MIDTOWN COMMONS

SUMMARY OF DRB II RECOMMENDATIONS

2301 East Union Street
Project No. 3028872

Design Recommendation III
03/13/2019

3c SKYBRIDGE AT EAST UNION AVENUE

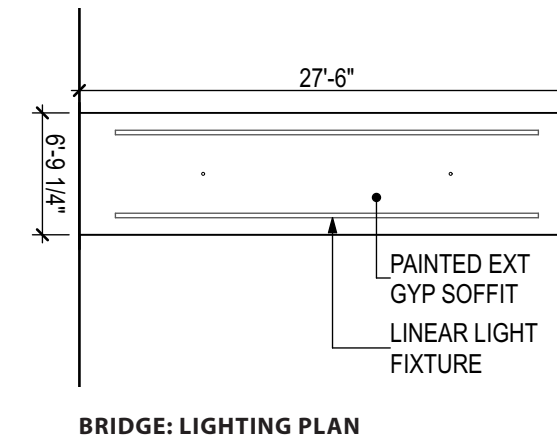
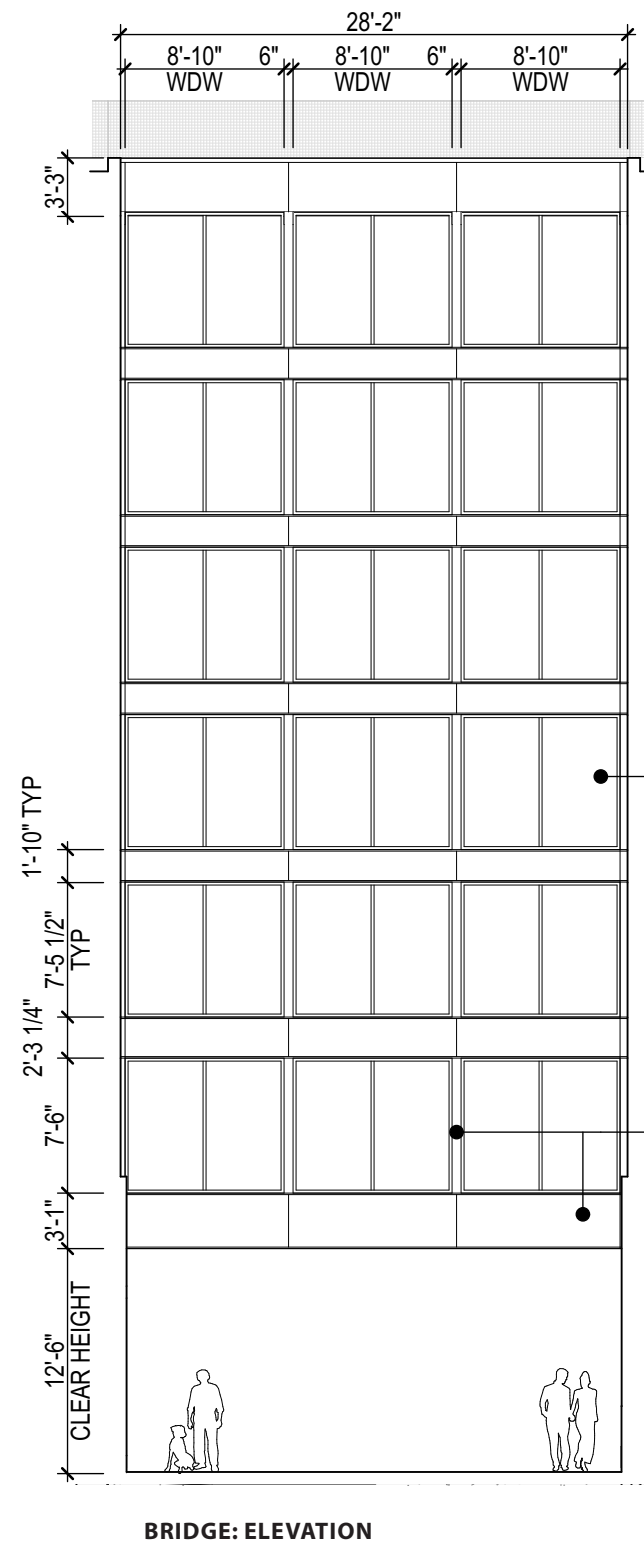
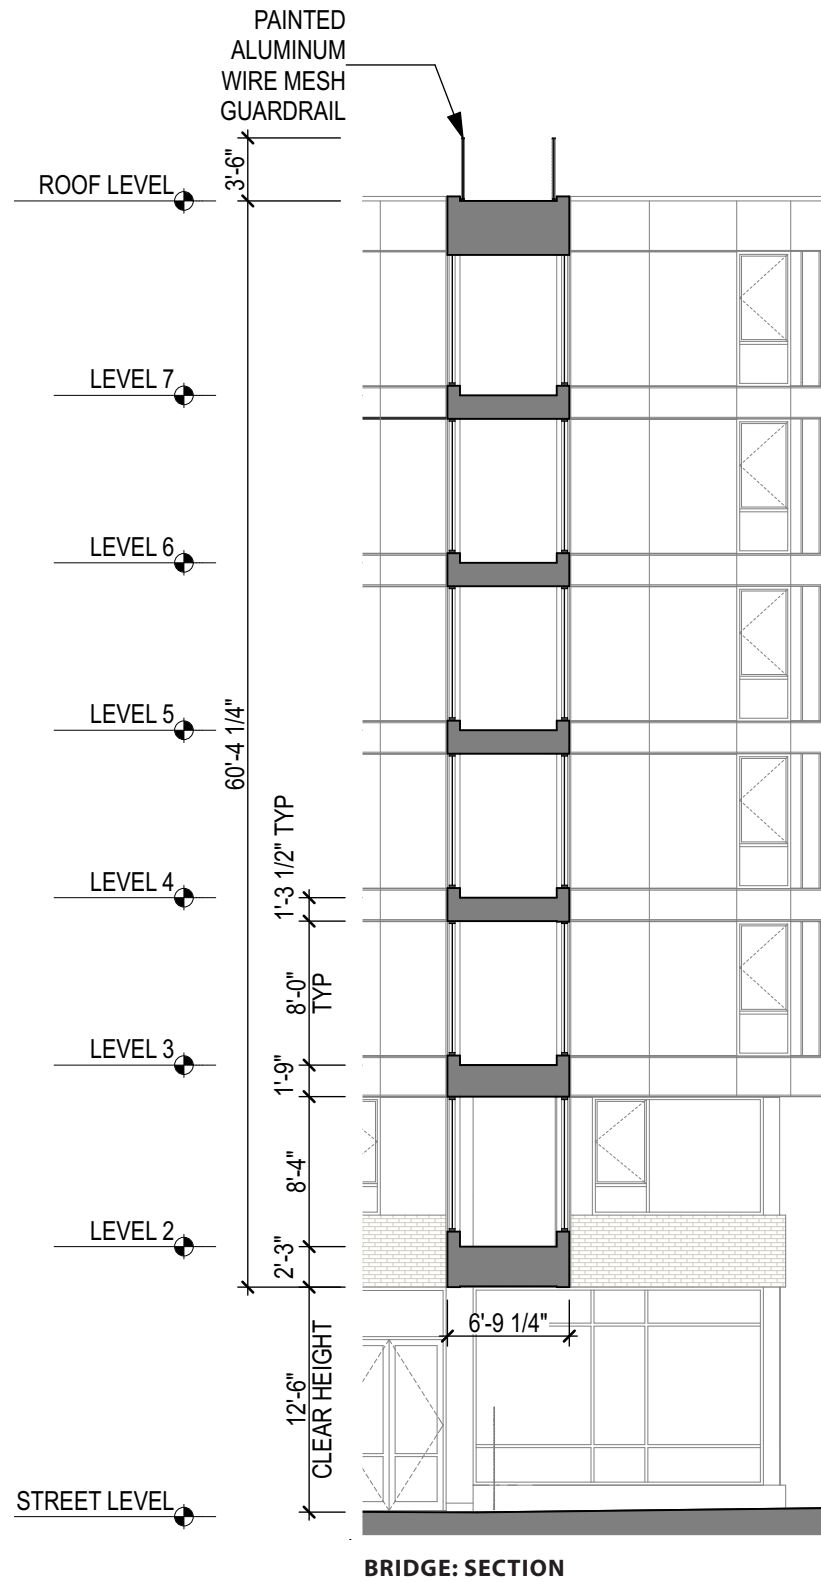
- i. At the previous meeting the Board asked for an exploration of the removal of the lowest level of this skybridge or even its complete elimination; there was concern that the 'closure' of this portal from the second floor to the seventh presented a significant impediment to this portal achieving the welcoming character that the Board, the public and the applicant had identified as critically important.
- ii. At this meeting, the Board recognized this skybridge as a potentially project-defining element, and asked for a careful consideration of its composition as either a substrate for art or carefully-wrought "other" in the larger architectural composition.

- i. Removing the lowest level of the skybridge was studied, but had undesirable effects on street-level spaces: reduces transparency, requires residential use area where retail is preferred, and limits flexibility in future re-demising of retail spaces. The bridge is a corridor connecting units in the NW building to the elevator, lobby, and exit stairs in the NE building. To remove this connection requires adding another residential lobby and elevator at street level in the NW building, and an enclosed additional exit stair at street level in both the NW and NE buildings.

- ii. The primary masses of the buildings to either side of the bridge are heavily patterned by windows, siding textures, and art. The volume of the corner plaza is also identified as a location for a significant art installation. The bridge does serve an important function as a gateway element to the central square, however, the design team strongly feels that the appropriate treatment of the bridge among all of its neighboring elements, is to keep it as neutral and "quiet" as possible, not to treat it as another art canvas. Lighting will be integrated into the bottom surface (soffit) of the bridge, throwing extra light on the ground plane below and calling subtle attention to this gateway zone without distracting attention from the more engaging mural and ground plane patterning that draw people into the central square.

3d DIAGRAM - 24TH AVENUE PORTAL - PEDESTRIAN | VEHICULAR SHIFT IN MIXING

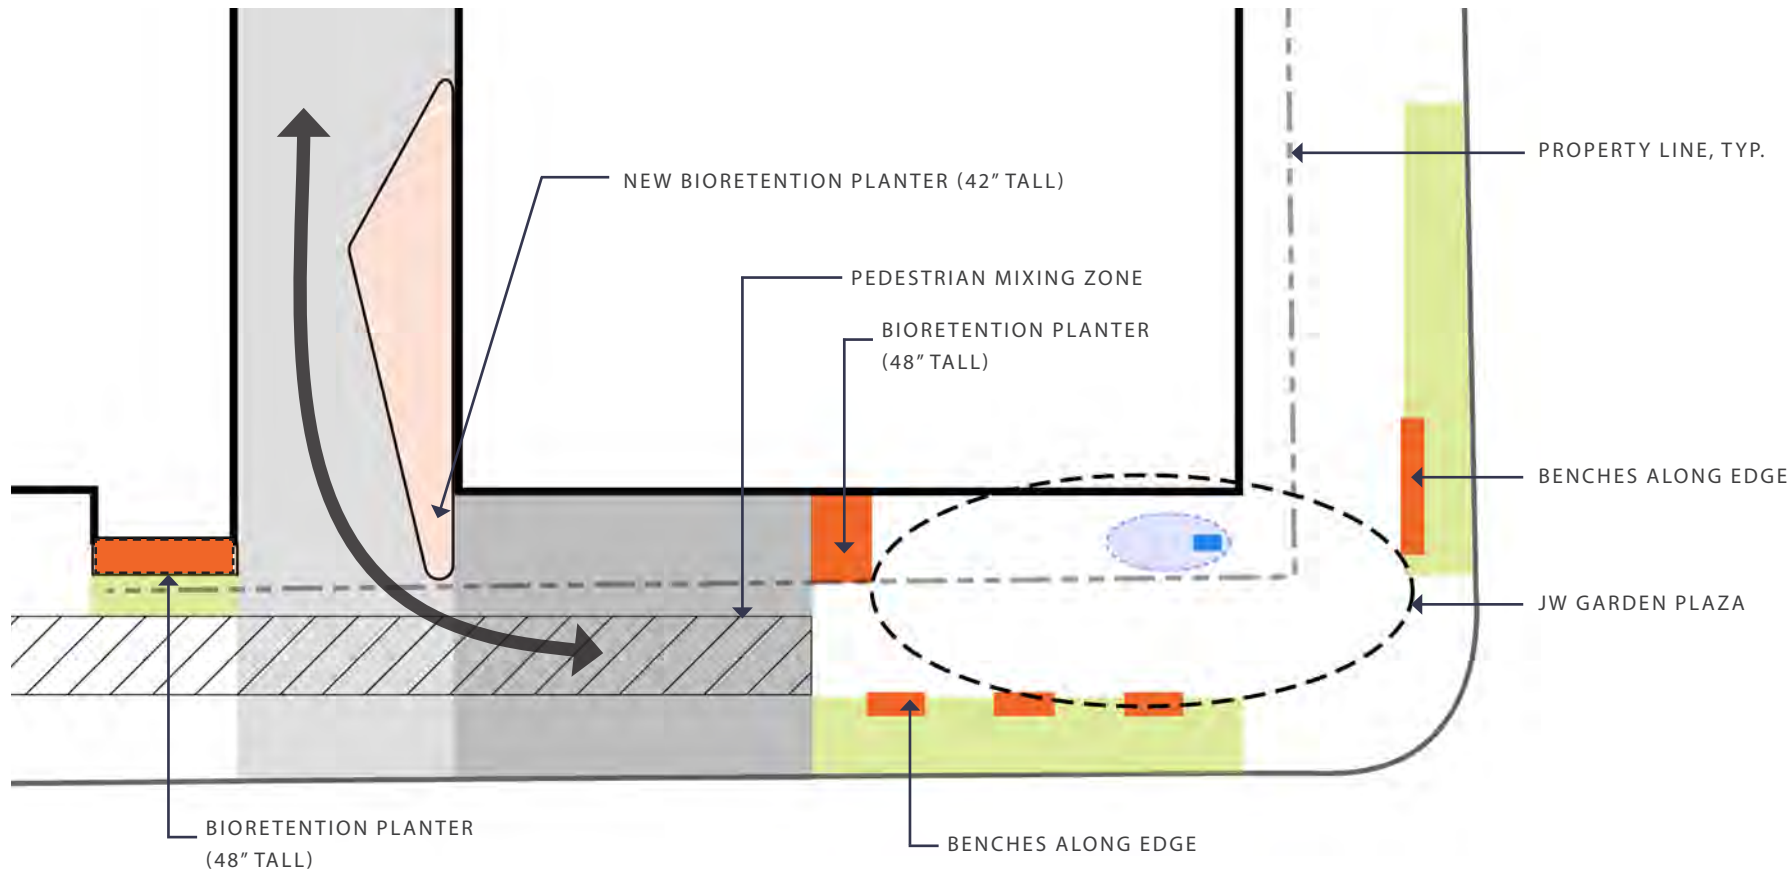
- i. The Board enthusiastically supported the removal of the skybridge, and the site planning changes made possible by the consolidation of solid waste areas.
- ii. The Board found the larger curb cut and acceptable solution given the groundplane, architectural, and landscape elements added to insure the safety of pedestrians and other users of the fountain plaza.

- ii. Items have been maintained. To ensure additional safety between pedestrians in the portal and vehicles existing the garage, another bioretention planters has been added at the north edge of the portal.
- Circulation into and out of the 24th Avenue Portal has been directed to a defined mixing zone at the public sidewalk.
- An added bioretention planter provides protection to the pedestrian from the traffic movement of the parking ramp and loading zone. Paired with the raised bioretention planter at the edge of the retail / JW Garden Plaza, these elements direct pedestrian traffic into a single location / mixing zone at the sidewalk and provide a sense of enclosure for plaza and fountain patrons.
- A defined vehicular pattern on the pavement establishes defined areas for cars and alert pedestrians to a change in use underfoot.

5a PROPOSED TREE LOCATION & SIZE AT INSTALLATION (CURRENT PROPOSAL)

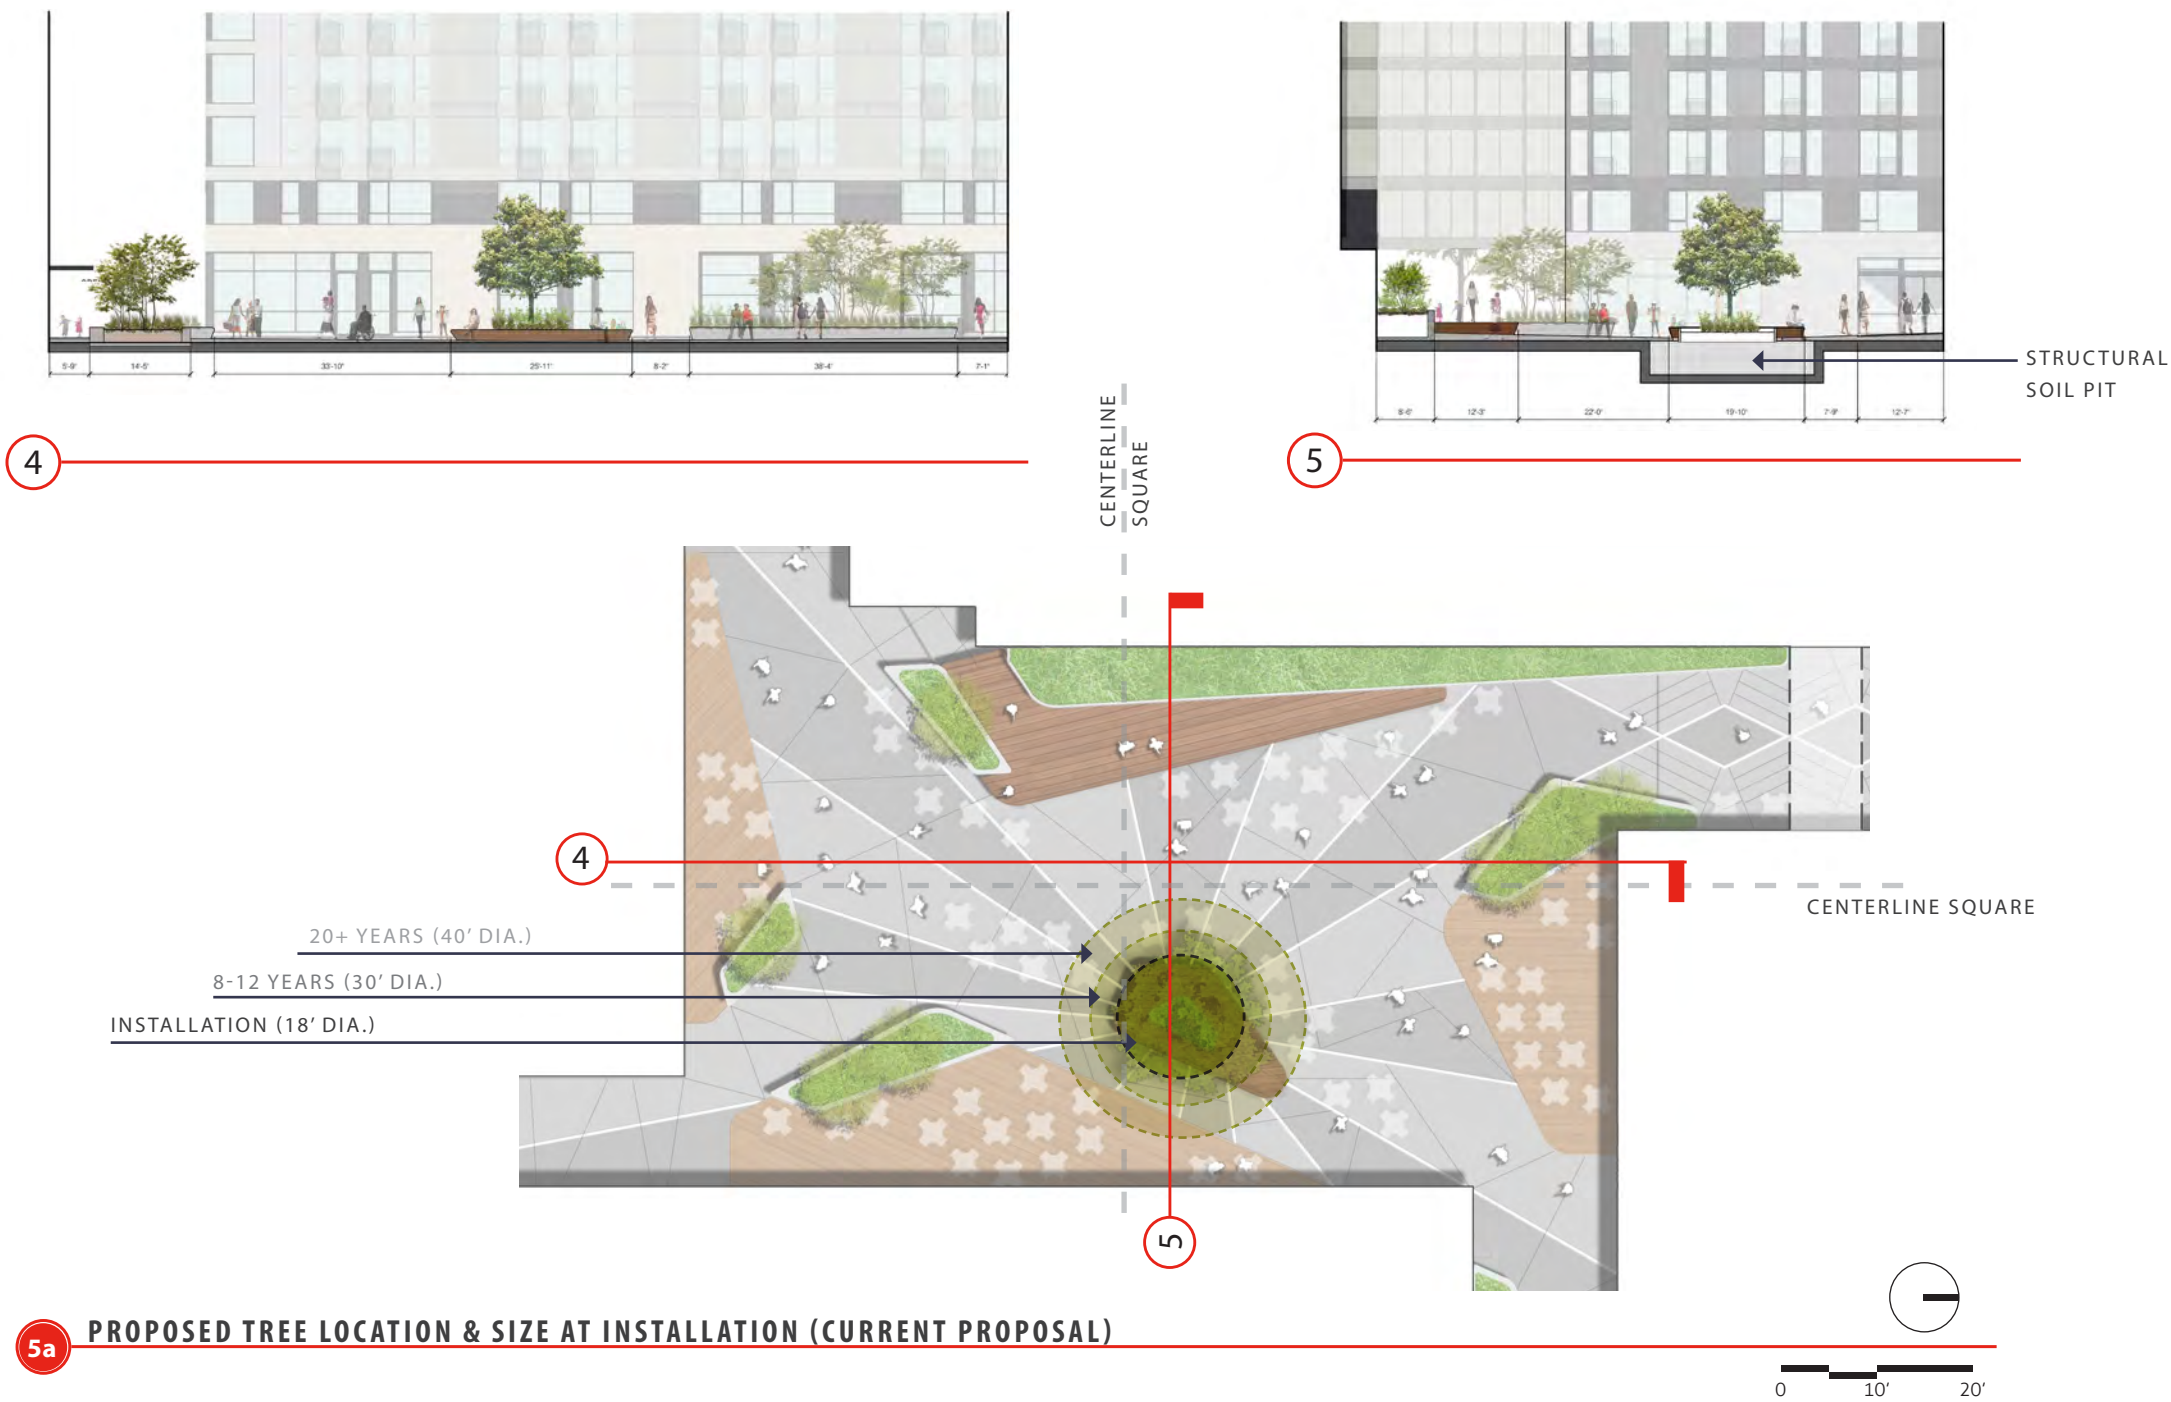
- 5a TREE LOCATION** - After a wide-ranging discussion of the location and “role” of the proposed tree, a majority of the Board supported the relocation of the tree away from the center of the courtyard with the following notes:
- i. Egress to and from retail storefronts not to be compromised
 - ii. The accommodation of a wide range of users and uses be carefully considered.

The tree located near the center of the plaza allows it to be used daily as a waypoint, focused on from all portals as users enter the plaza, and a key scale element to visually express the pedestrian scale of the Central Square . As a retail oriented square, the tree location needs to consider retail spill out and use along the building edges and from the building interiors, provide a central focal point for orientation.
